**VIRGINIA ELECTRIC AND POWER COMPANY  
RICHMOND, VIRGINIA 23261**

**VIRGINIA ELECTRIC AND POWER COMPANY (DOMINION)  
NORTH ANNA POWER STATION UNITS 1 AND 2  
SUPPLEMENTAL INFORMATION FOR REALISTIC LARGE BREAK LOSS OF  
COOLANT ACCIDENT (RLBLOCA) ANALYSIS RESULTS  
PROPOSED TECHNICAL SPECIFICATIONS CHANGES AND EXEMPTION  
REQUEST FOR USE OF FRAMATOME ANP ADVANCED MARK-BW FUEL**

**Dominion Supplemental Responses to NRC Request for Additional Information**  
**Questions 6 and 11a from Dominion's August 20, 2003 letter (Serial No. 03-313A)**  
**and questions posed in an August 29, 2003 NRC facsimile**

**Figure 11-1 PCT Independent of Elevation**

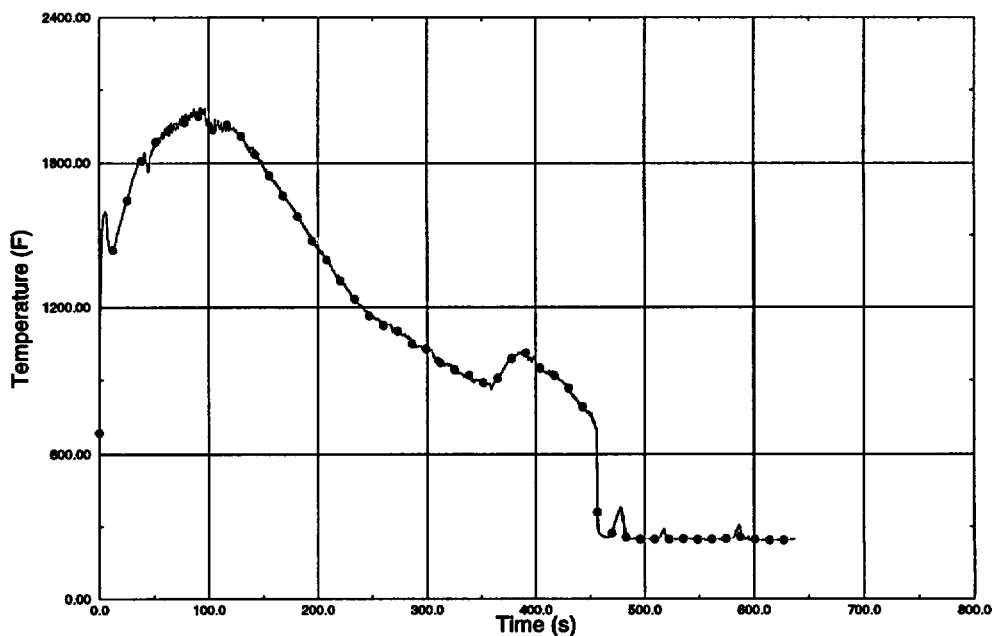
Q11. Downcomer Boiling - The containment pressure in Figure 7.2-33 indicates that the containment pressure is at about 30 psia and continues to decline at 200 seconds into the limiting LBLOCA. Figures 7.2-23, 7.2-30, and 7.2-32 seem to indicate that downcomer boiling occurs at about 375 seconds into the transient. The containment plot ends at 200 seconds and it appears from Figures 7.2-23 and 7.2-32 that the calculation was terminated at ~460 seconds. At ~460 seconds, the PCT drops to ~450°F. At this time, the (extrapolated) containment pressure is 30 psia or less. The saturation temperature at 30 psia is ~250°F or less, but the drop in PCT stops at ~450°F. 10 CFR 50.46 requires that analyses to be run until the core is quenched.

- a. Extend the analysis results tables and graphs, particularly Table 7.2-11 and Figure 7.2-33, to beyond the time that stable and sustained quench is established.

*The calculation of the limiting North Anna Unit 2 realistic large break LOCA transient was extended to 640 seconds. The elevation independent peak cladding temperature is shown in Figure 11-1. It can be seen from this figure that stable and sustained quench is established after about 450 seconds. The minor temperature spikes seen in the figure after 450 seconds are due to intermittent liquid carryover to the reactor vessel side of the break. Figure 11-2 shows that the reactor vessel liquid inventory remains reasonably constant, exhibiting a rising trend.*
